Model: Martini-C1		Date: 17-Oct-02	No.: MB064001
Modified Article: Parts Catalog Correction		Prepared by: K. Miura	
From: Technical Services sec. Service Planning Dept.			
Reason for Modification:	☒ Parts catalog correction ☐ To facilitate assembly ☐ Part standardization	☐ Vendor change ☐ To improve reliability ☐ Other	☐ To meet standards ()

Please correct your Parts Catalogs as follows:

Page 64

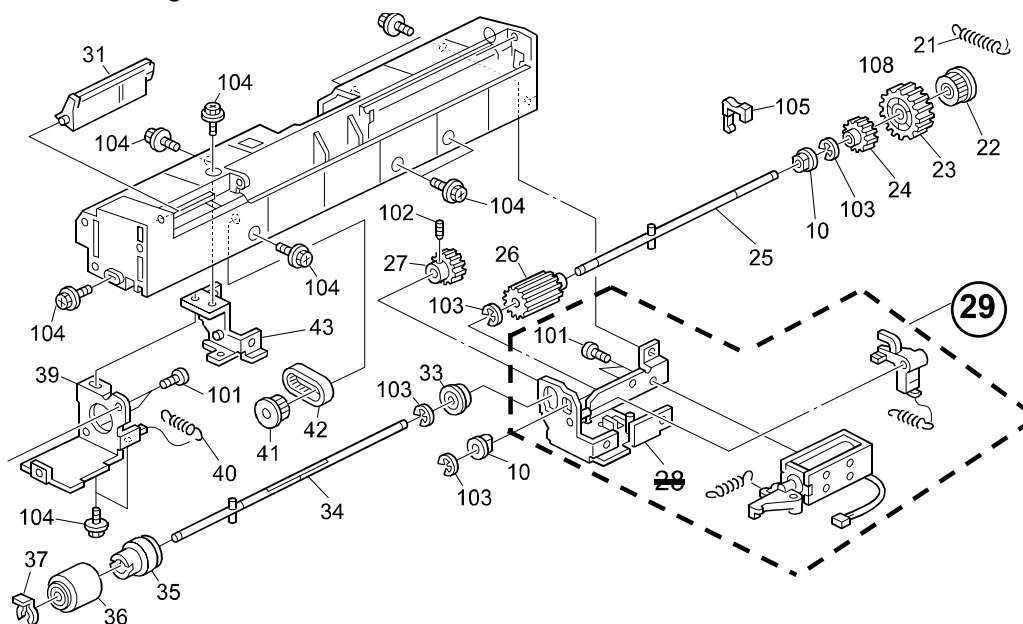
Illustration change:

Page 125

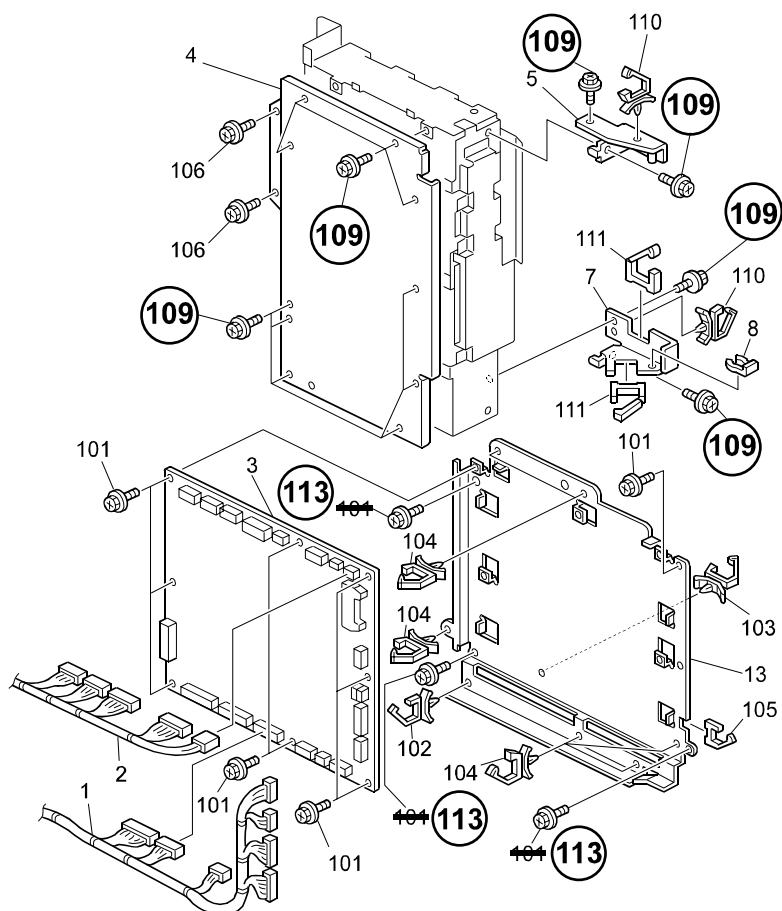
Part number addition, index change (only in 3 places circled below):

Part number	Description	Old index	New index	Note
03603008B	Screw - M3X8	101	113

Page 126

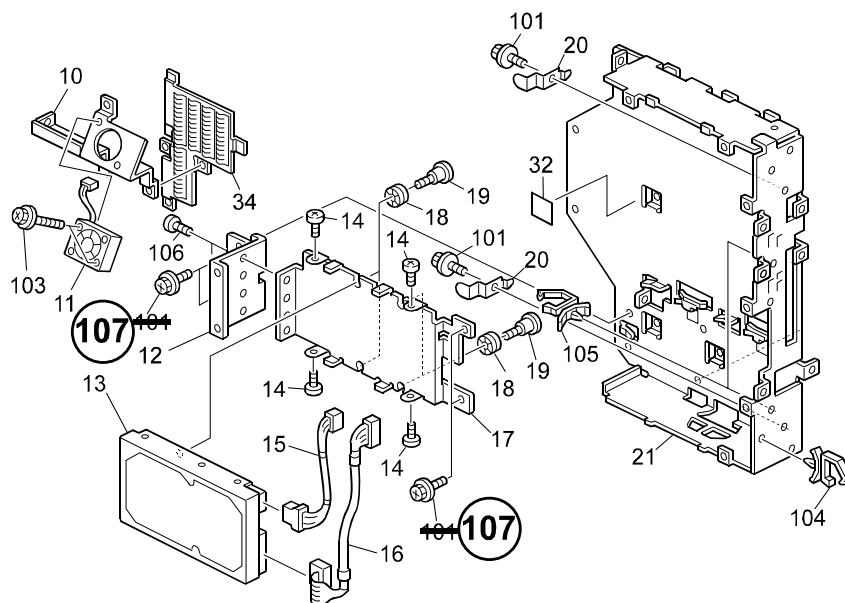
Illustration change:

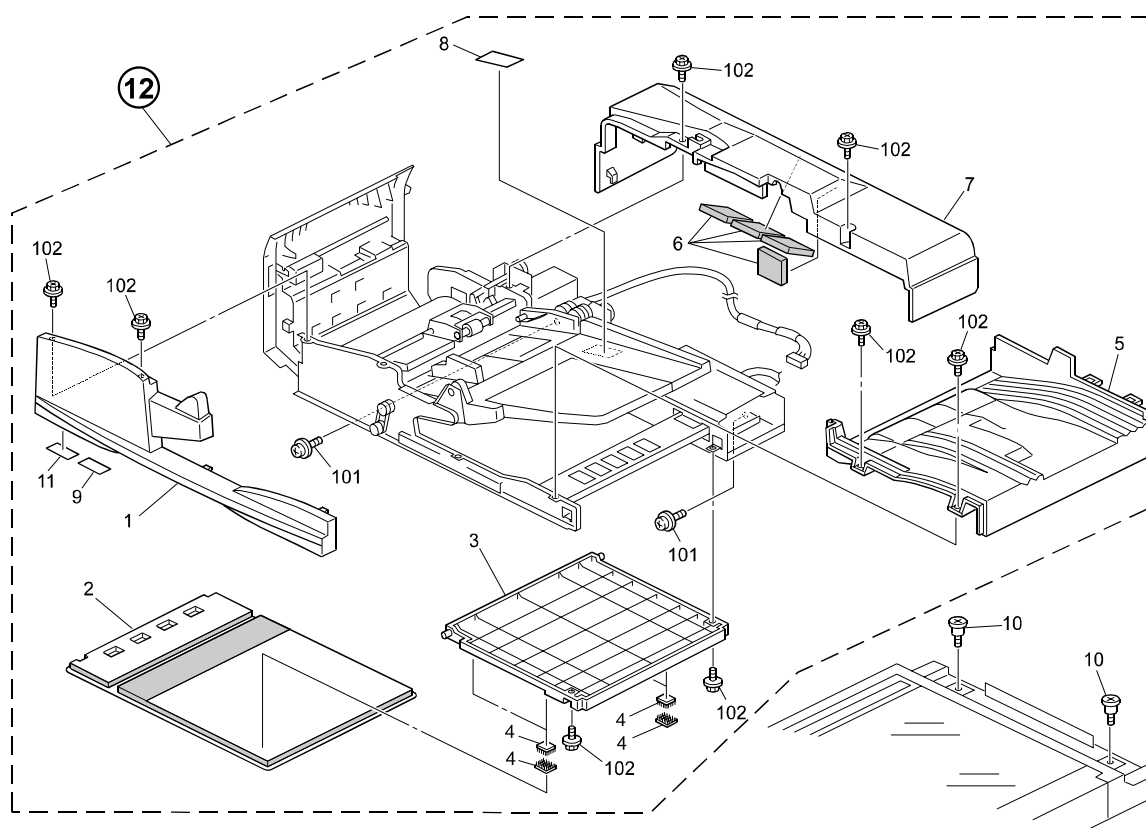
Please add the following part to your Parts Catalog:

New part number	Description	Q'ty	Page	Index	Note
B0657001	ADF Unit	1	21	12

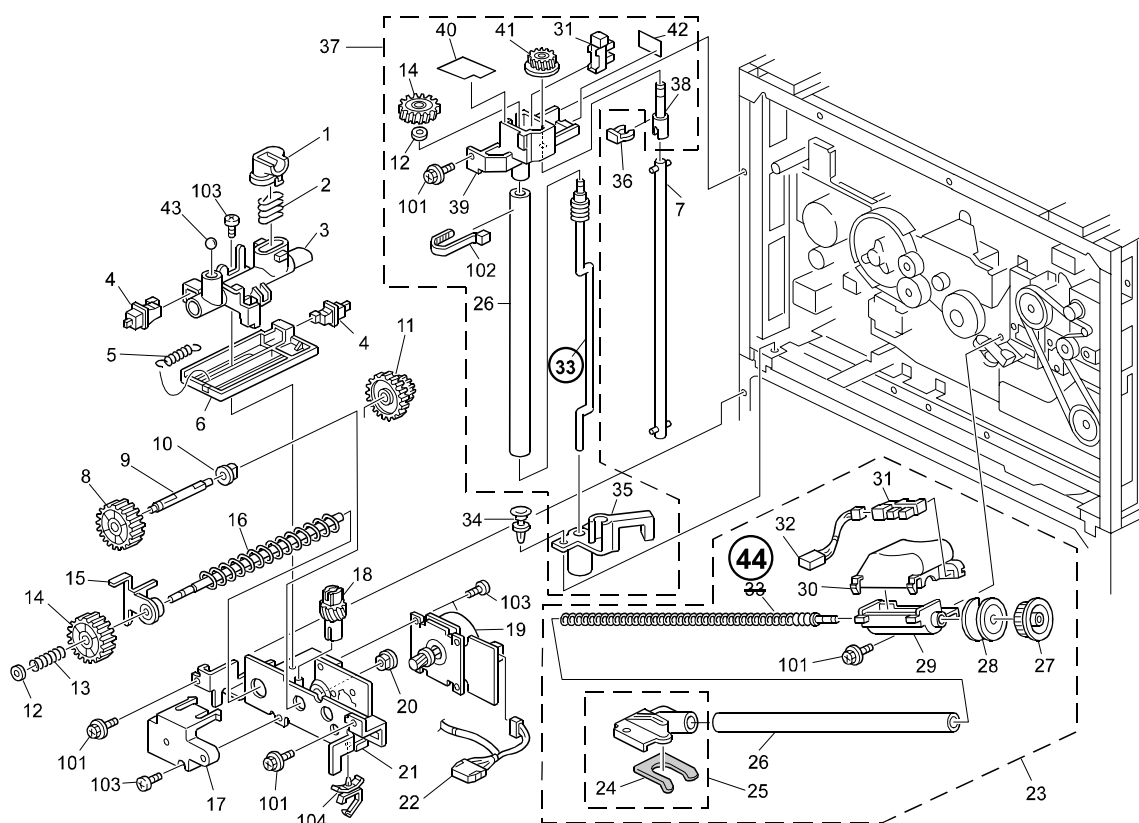
Note: Index #33 in the upper half of the illustration is correct, and should be left as is.

Part number	Description	Old Index	New Index	Page	Q'ty	Note
B0653633	Transport Screw	33 (Lower)	44	123	1

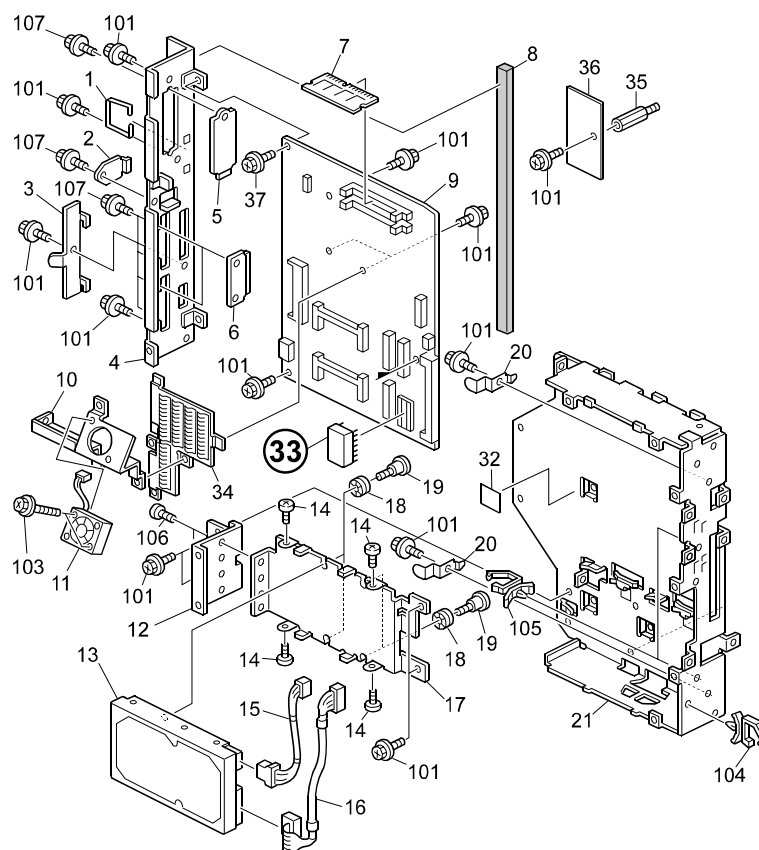
The description of the NVRAM has been changed as follows:

Part number	Old description	New description	Q'ty	Page	Index	Note
B0649099	Total Counter	NVRAM - Minus Counter	1	127	33

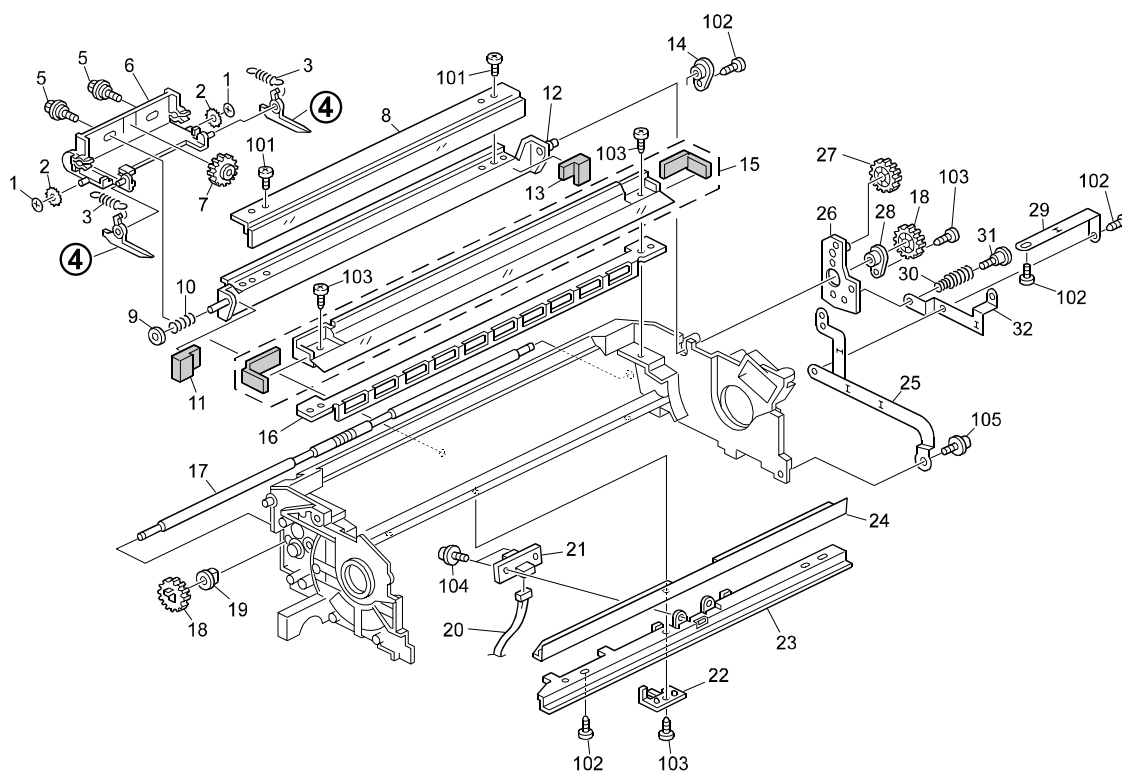
As the edge of the Pick-off Pawl can be damaged during transport, causing paper jams in the PCU section, a protective plastic covering has been added to this area.

Old part number	New part number	Description	Q'ty	Int	Page	Index	Note
AD025023	AD025024	Pick-off Pawl	2	O/O	89	4

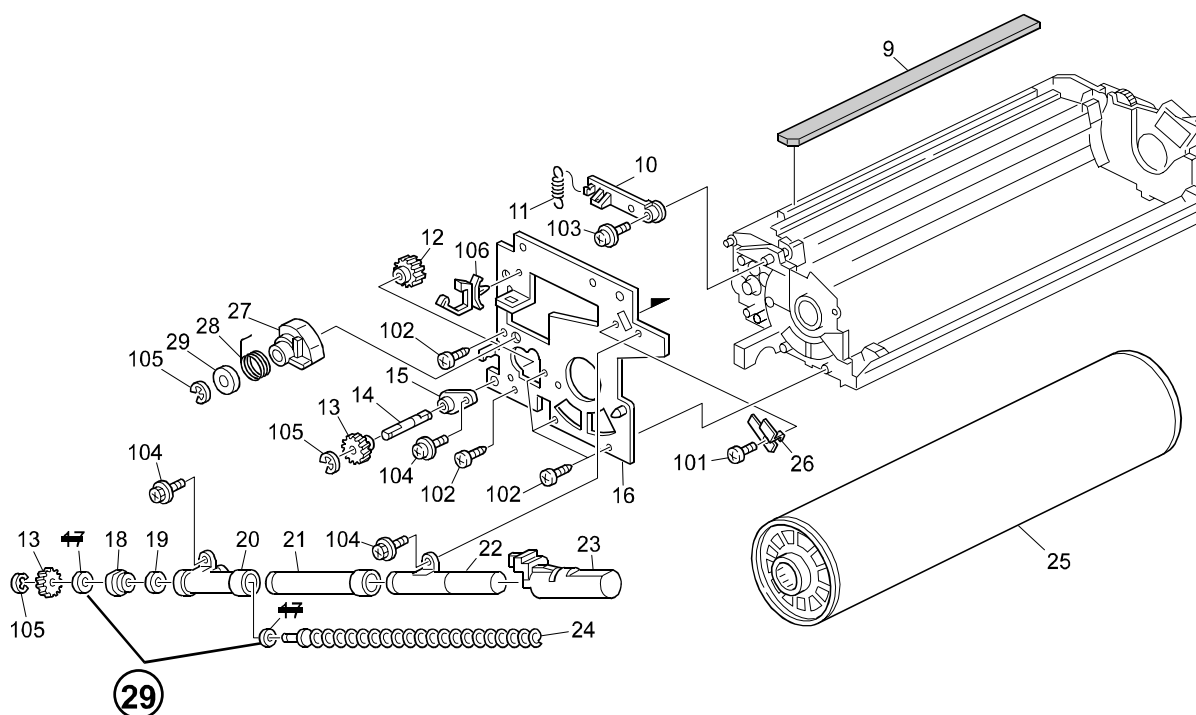
The part shown below has been standardized in all places used in the PCU.

Old part number	New part number	Description	Q'ty	Int	Page	Index	Note
AA132024	AA132208	Spacer - M6	2 -> 0		85	17	
		Spacer - M6	1 -> 3	O/O	85	29

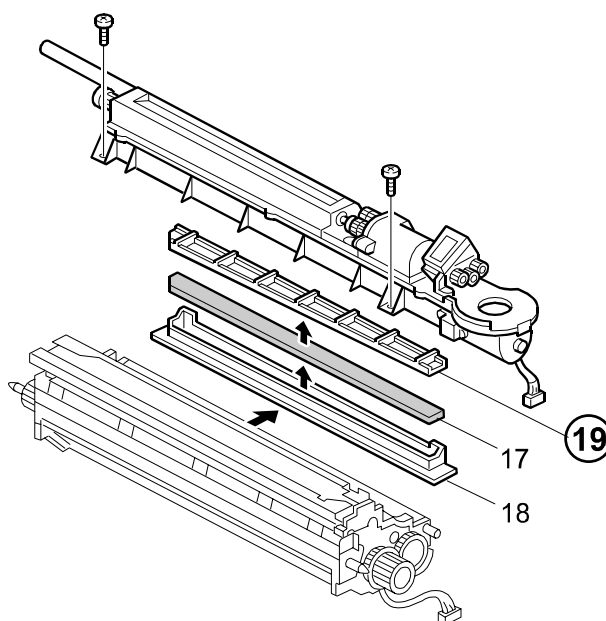
The following part has been added to further ensure that toner does not leak out of the development unit.

Part number	Description	Q'ty	Page	Index	Note
B0653108	Filter Plate	1	79	19

<Page 75 Index 41>

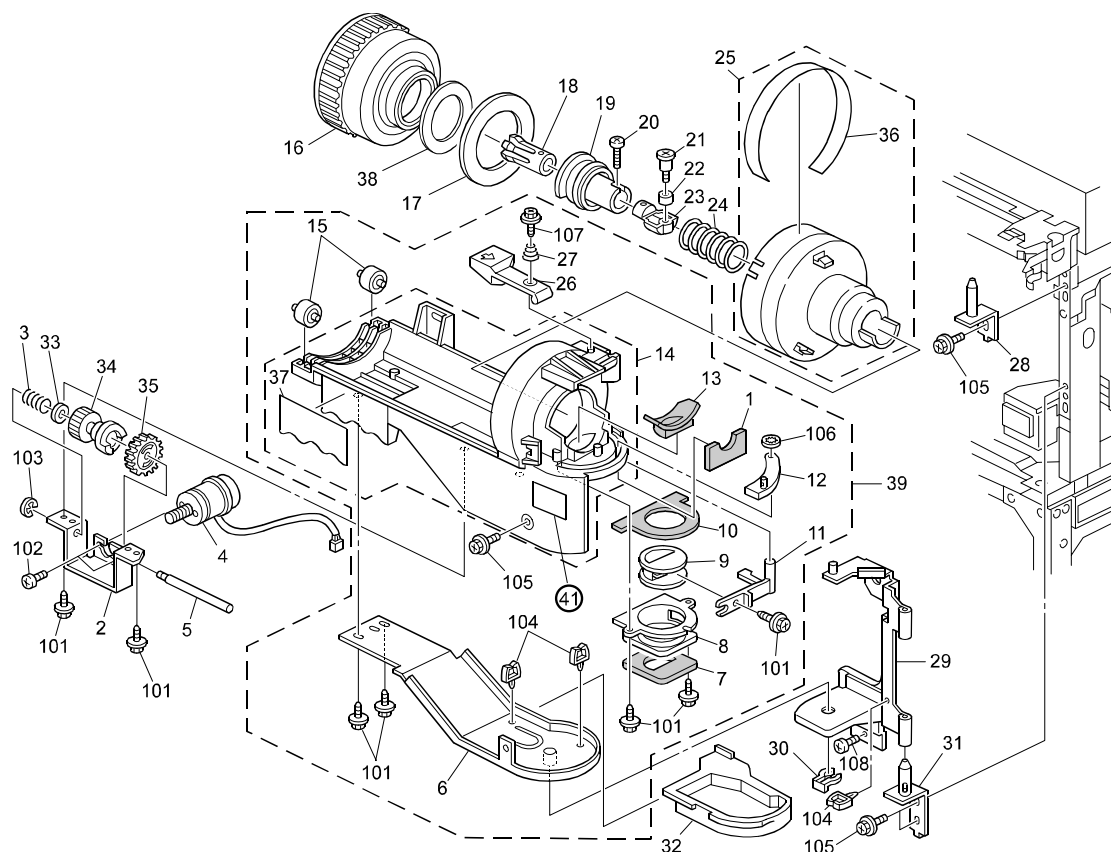
To further ensure that the toner bottle is set correctly, the decal shown below has been added.

Old part number	New part number	Description	Q'ty	Int	Page	Index	Note
	B0653342	Decal - Toner Supply	1		75 175	41 45

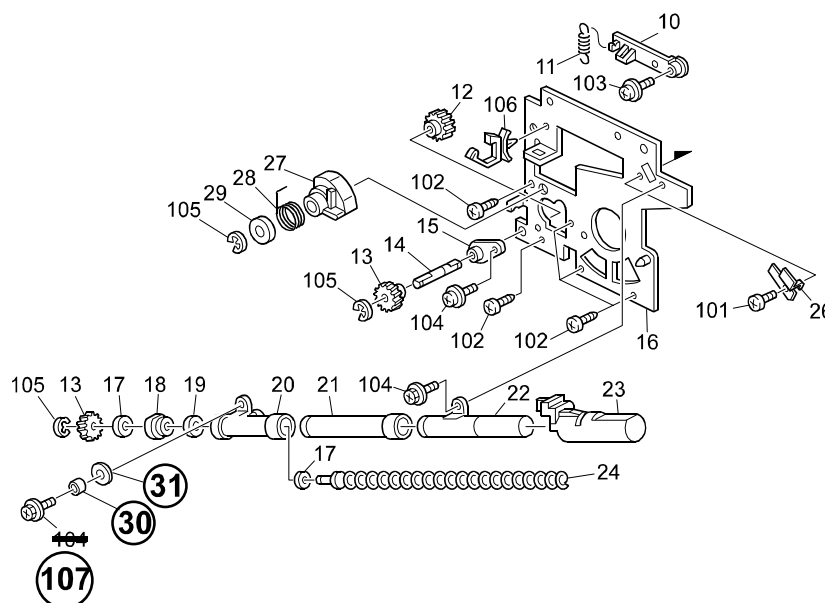
The following part has been added to ensure the Brush Roller Gear does not break:

Before installing the Cushion -T1 (A3764131), insert the Sleeve (AA130042) into the hole in the Cushion - T1.

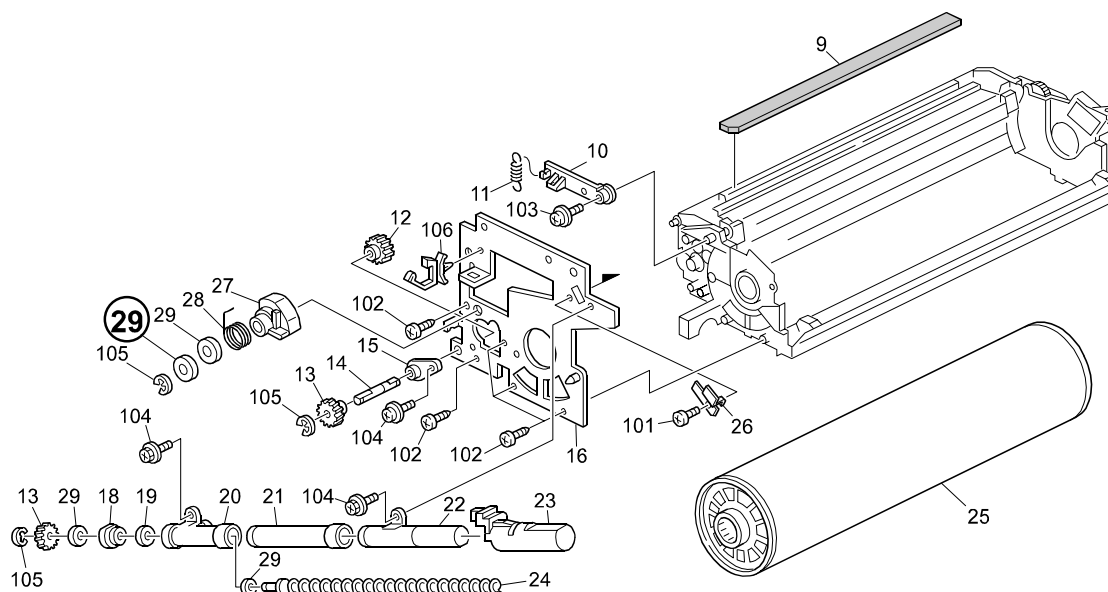
The following part has been added to ensure the Brush Roller Gear does not break:

Part number	Description	Q'ty	Page	Index	Note
AA132208	Spacer - M6	3 -> 4	85	29

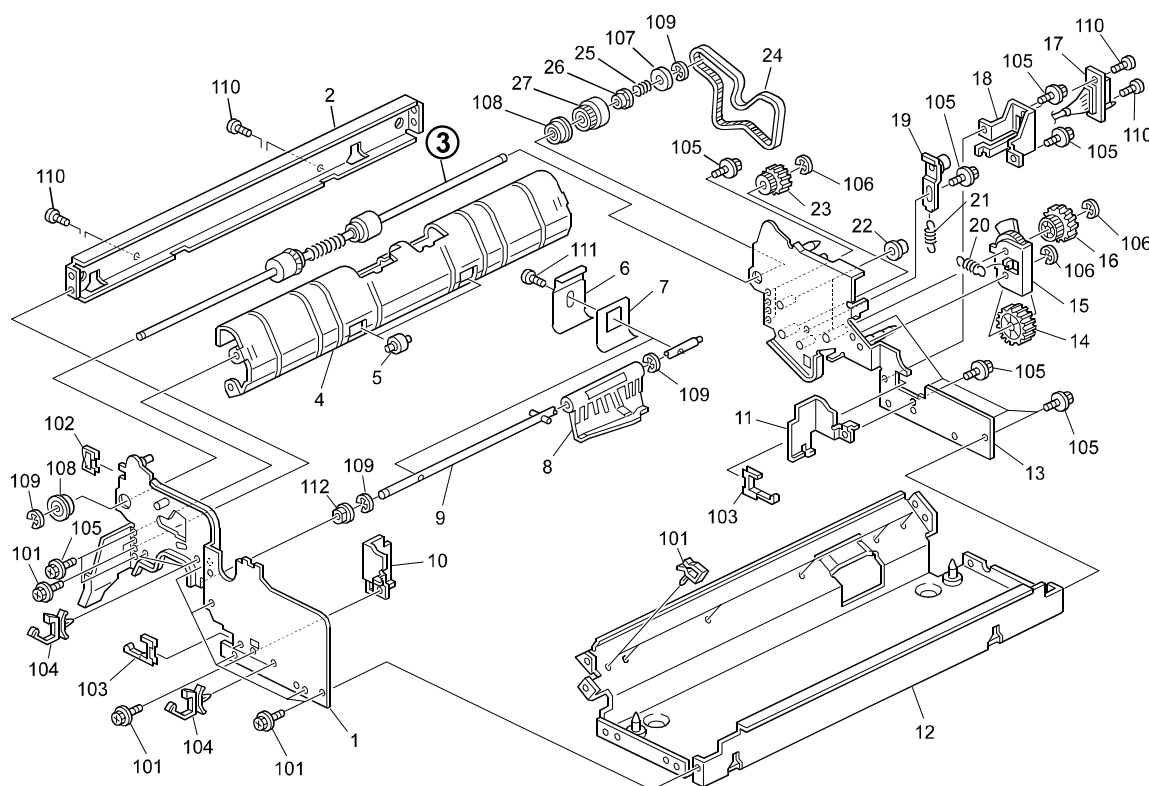
Although used on previous models, the two plastic rollers in between the rubber exit drive rollers that give the paper added stiffness (optional tray) have been deleted, as they are not necessary for this model.

Old part number	New part number	Description	Q'ty	Int	Page	Index	Note
AF020508	AF020581	Exit Drive Roller	1	X/O	107	3

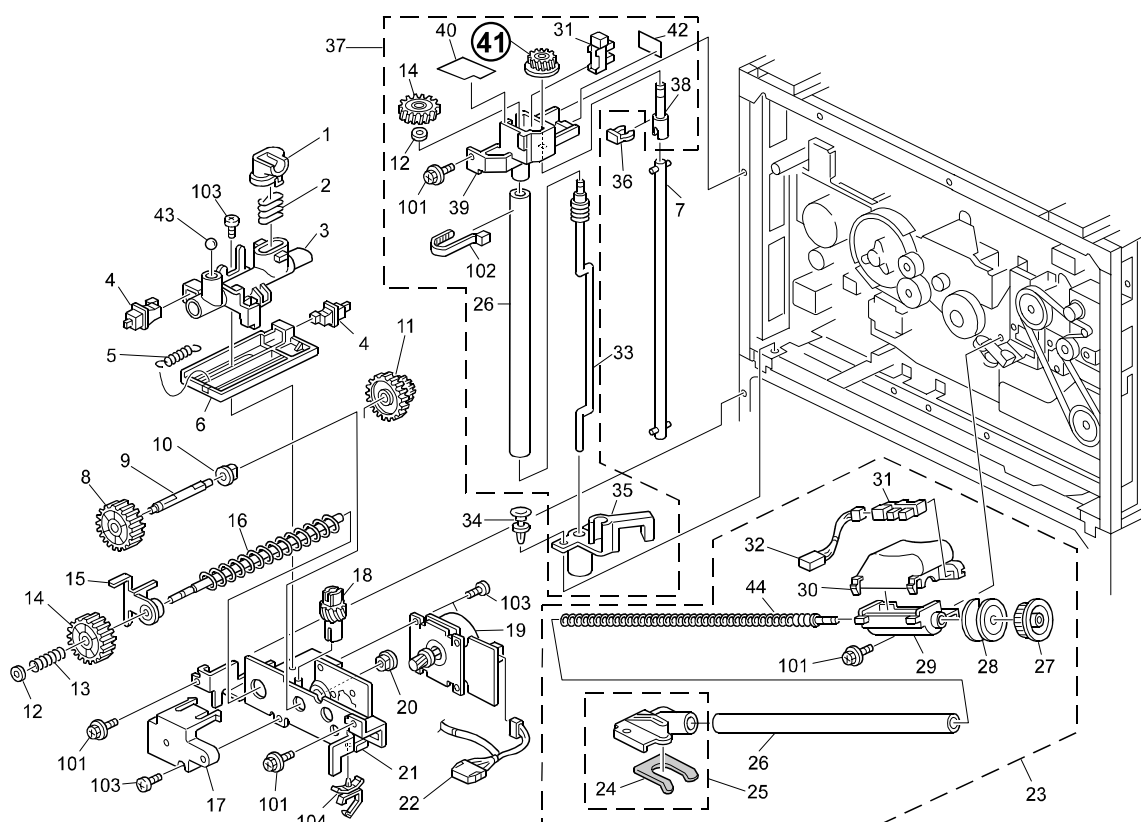
Part number	Old description	New description	Q'ty	Page	Index	Note
B0653645	Toner Collection Seal	Gear - 22Z	1	123	41
